# WOODBRIDGE SCHOOL DISTRICT New Woodbridge High School Bid Pac A

ADDENDUM NO.3 23 July 2012

Woodbridge School District New Woodbridge High School

ARCHITECT'S PROJECT NO: 11109

**PROJ.NO.:** 11109

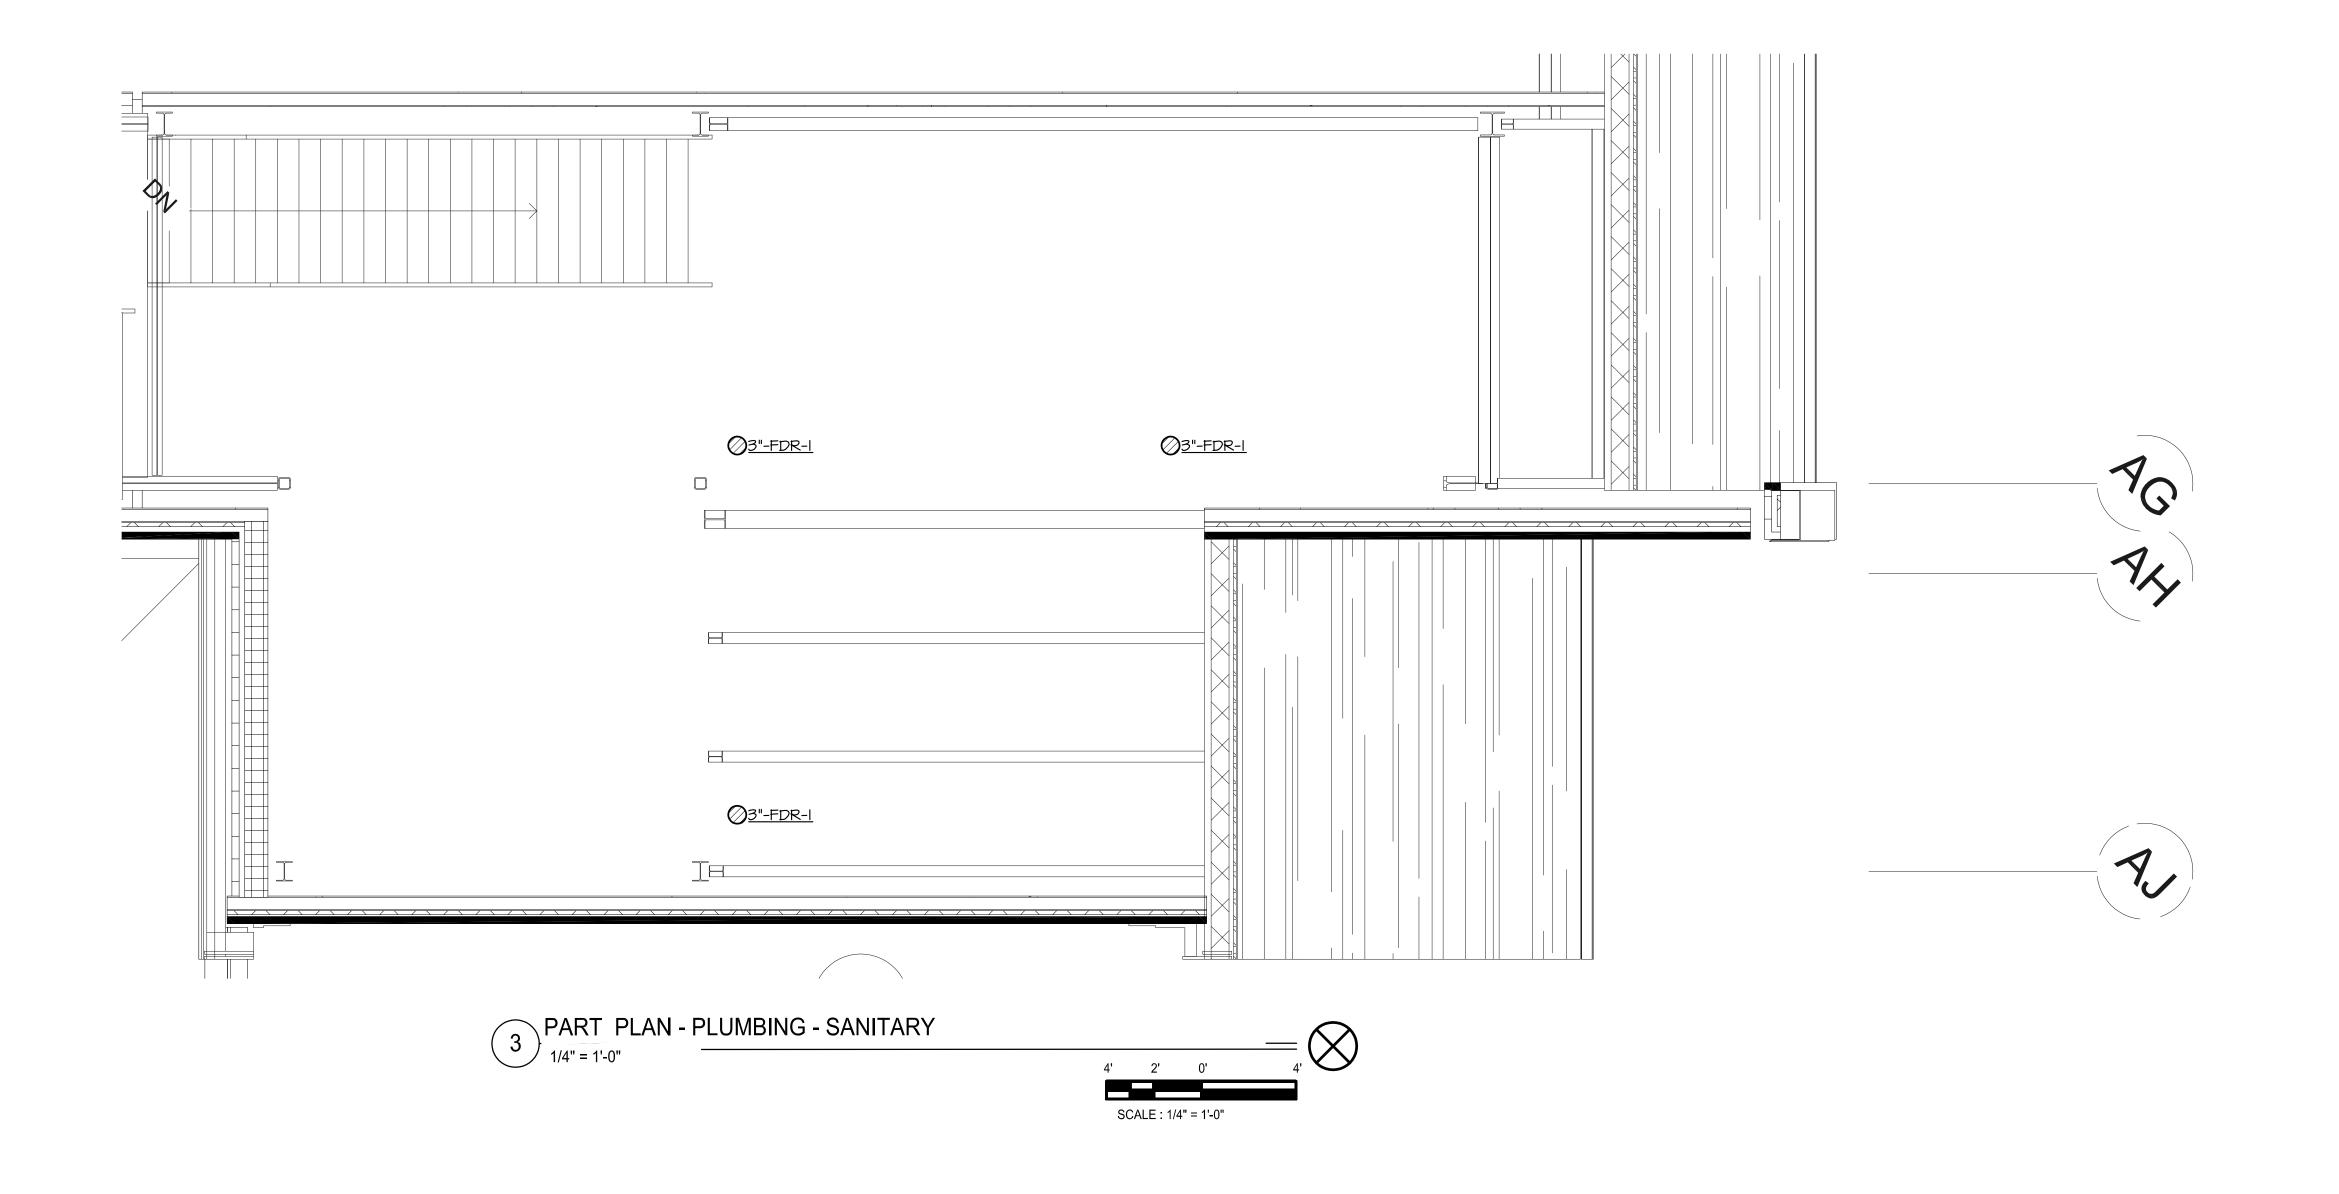
ADD SPARE CONDUITS FROM ELECTRICAL ROOM TO EXTERIOR OF BUILDING AS INDICATED. REFER TO DRAWING E50-OI FOR CONDUIT SIZES AND QUANTITIES.

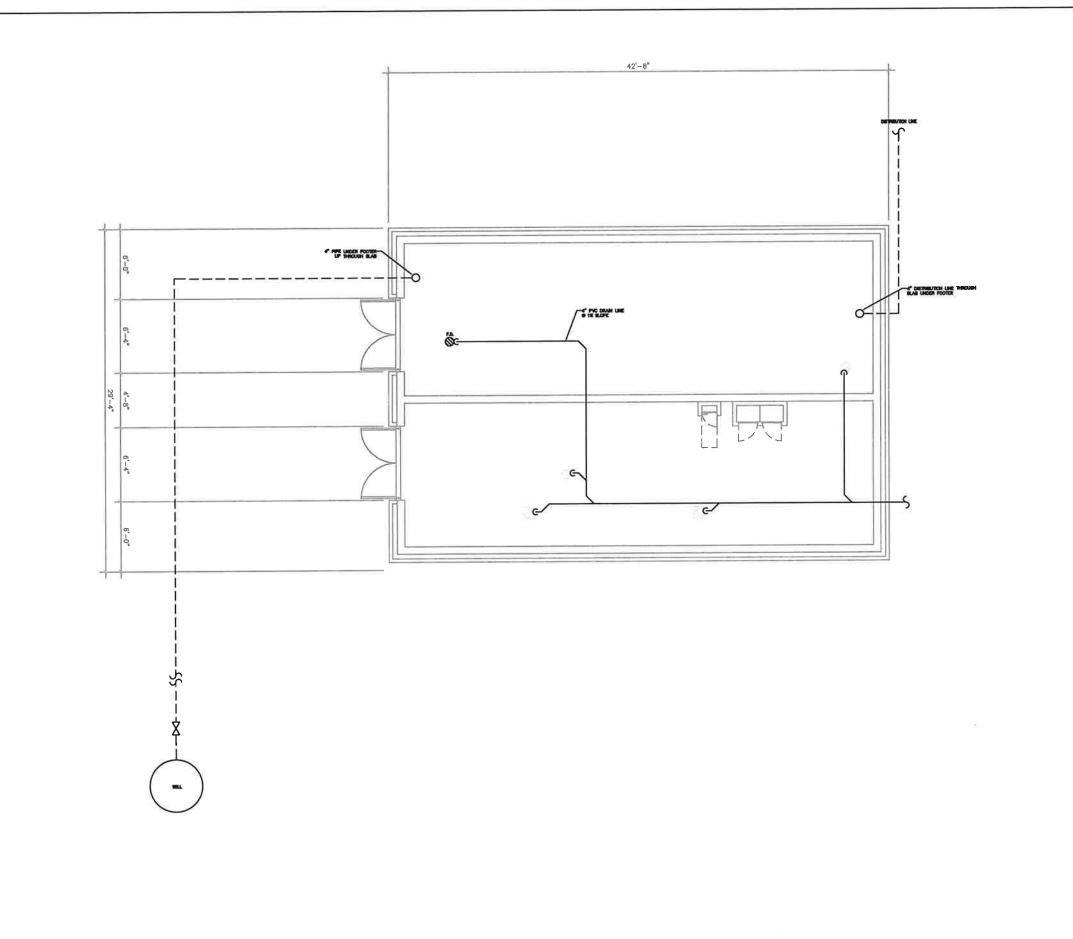
REVISE TO INDICATE STORMWATER PIPE THROUGH SLAB PENETRATION AND CLEANOUT.
